Public Works Service Operations

ITEM: Public Works Roofing Project Bid Award

Project: City of Bismarck
Public Works Roof Replacement
Project #: J22326

RE: Addendum #2

Partial Roof Plan
- Area A and
Detail - Alt. Bid
#3

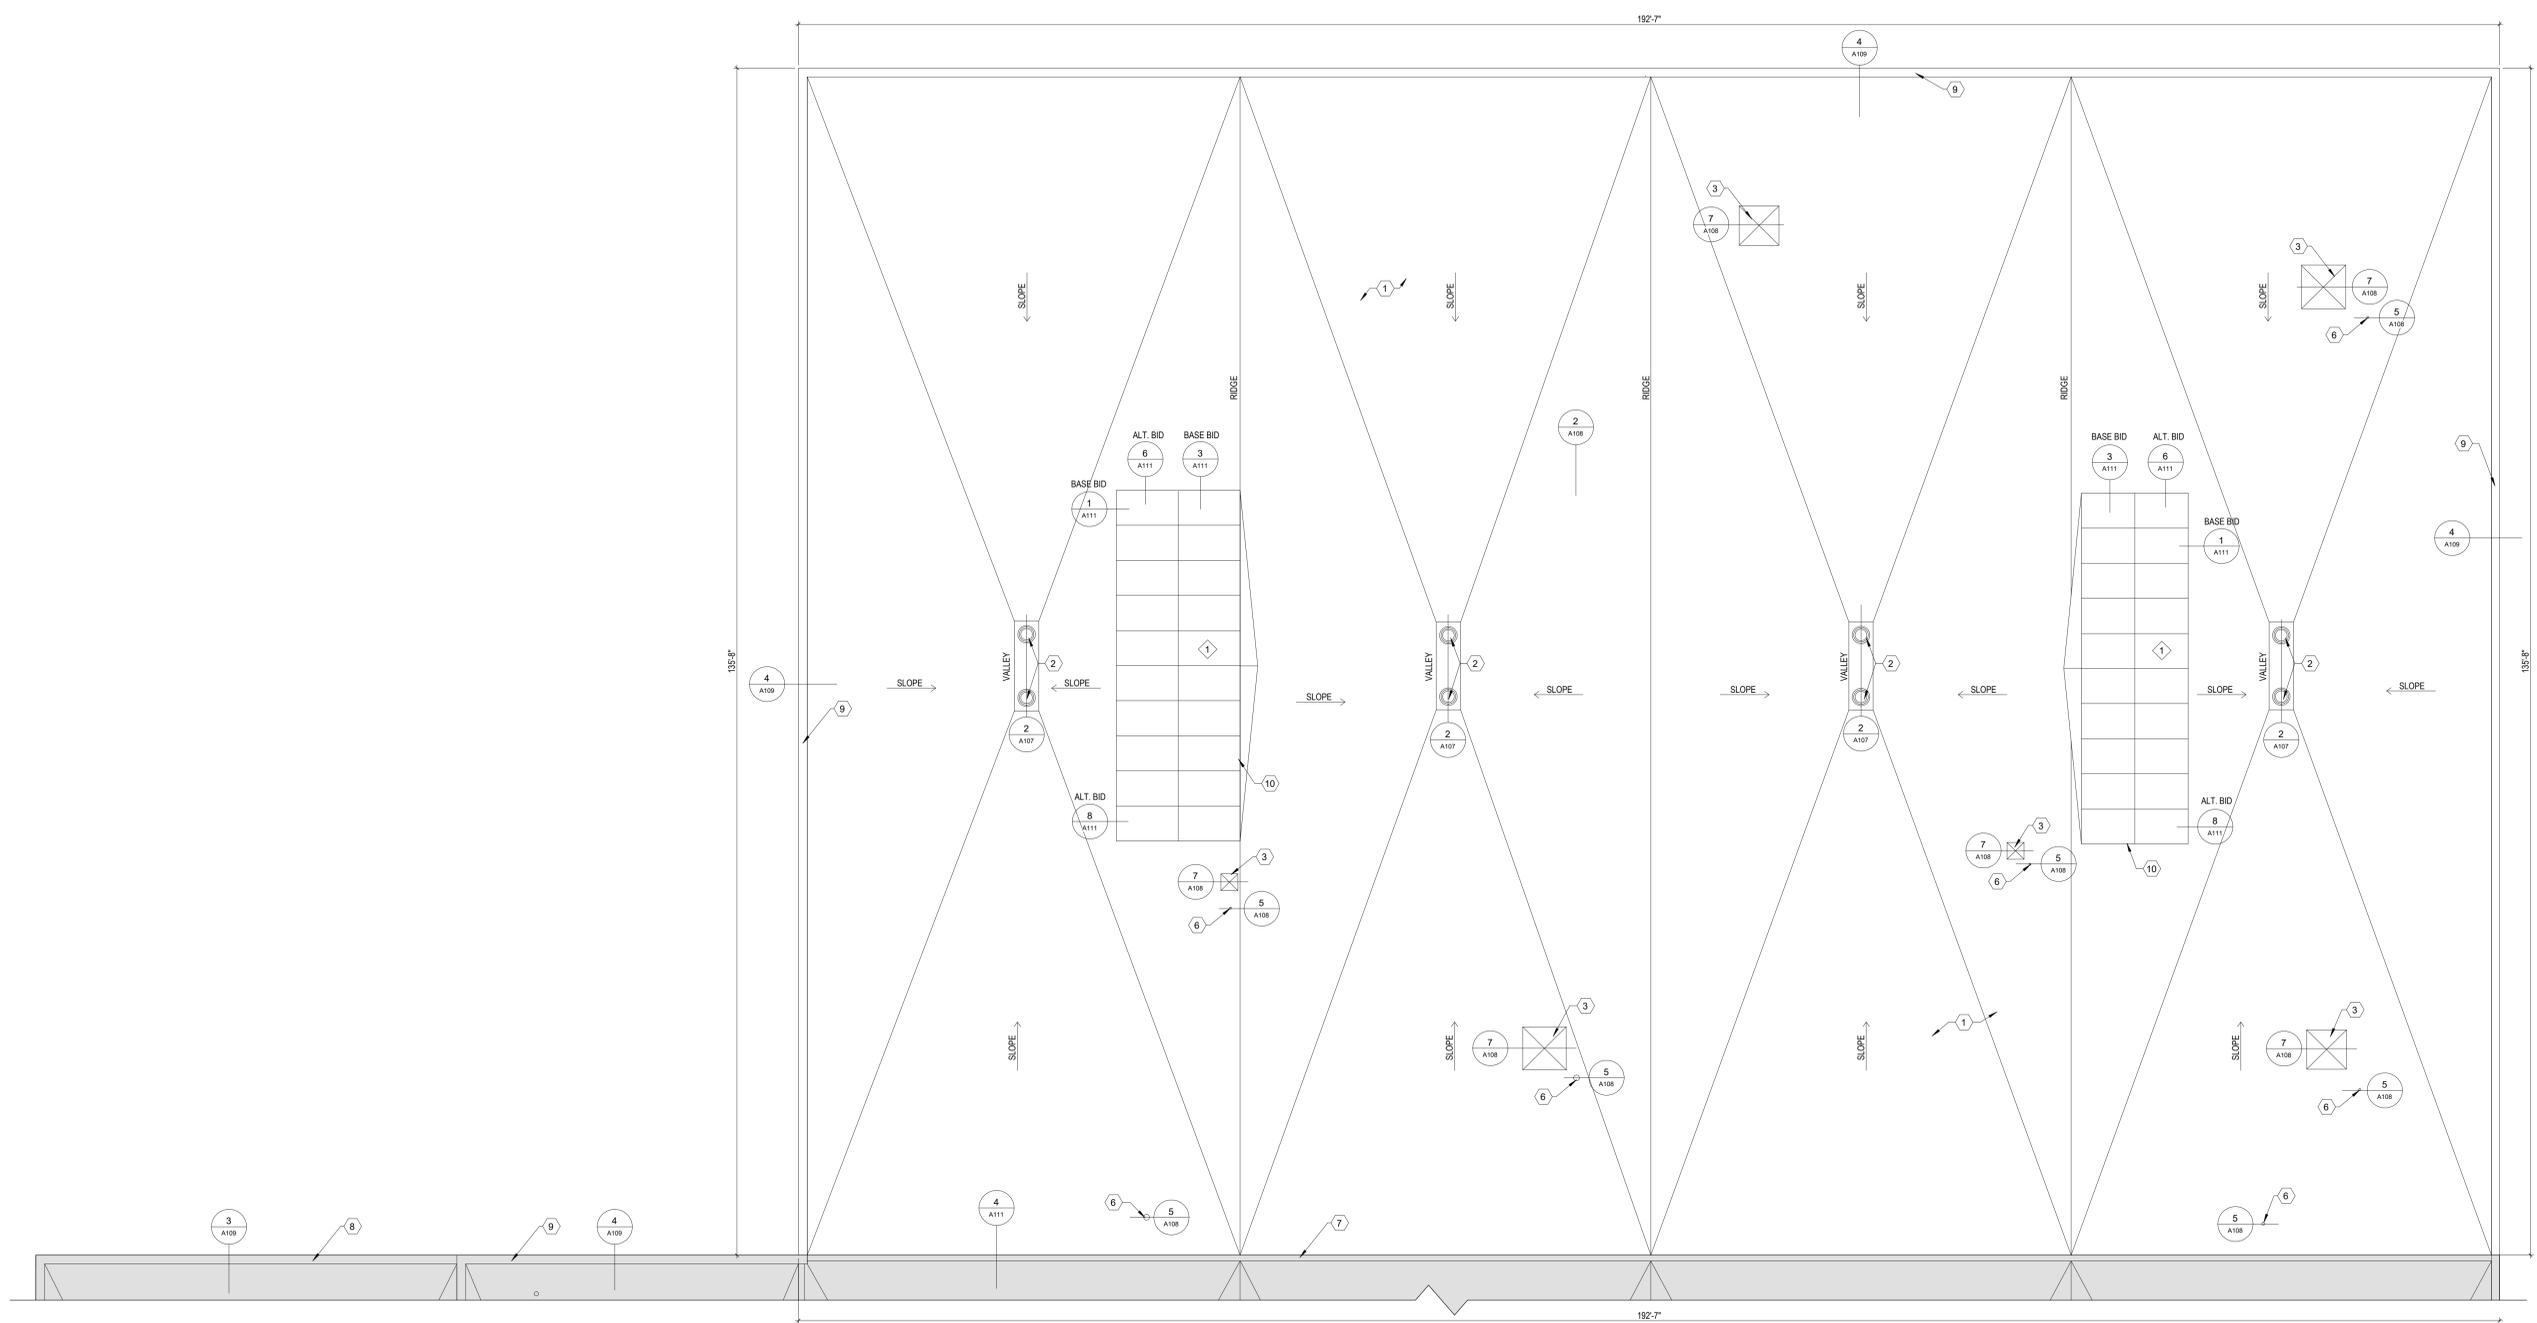
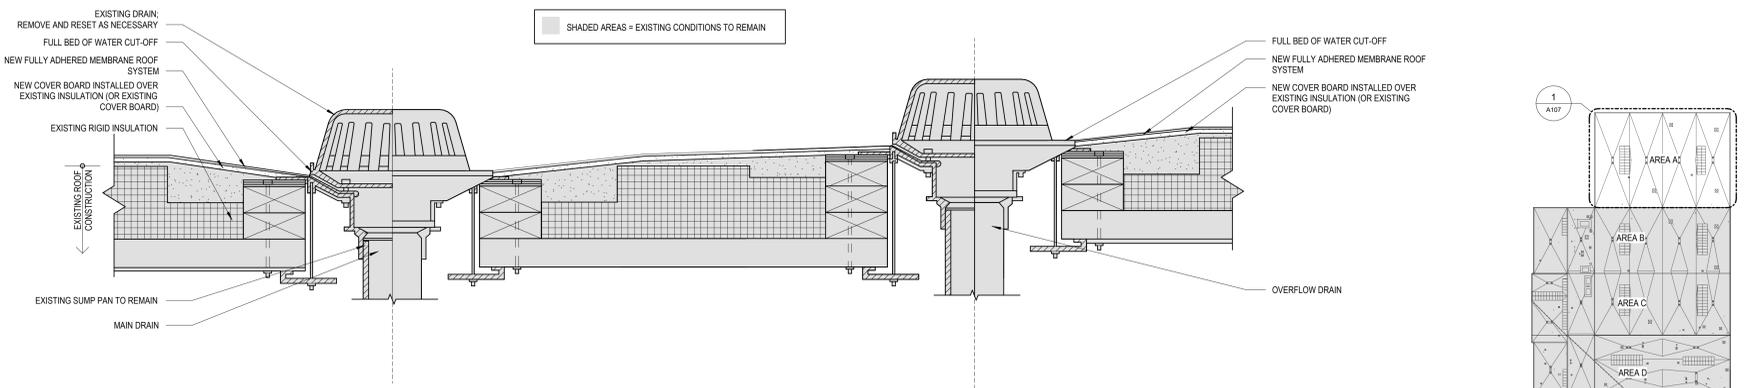
- 1. Add new sheets A107-A111 in their entirety. These sheets provide roof details for Alternate Bid #3, which is the fully adhered EPDM roof replacement option for the roof.
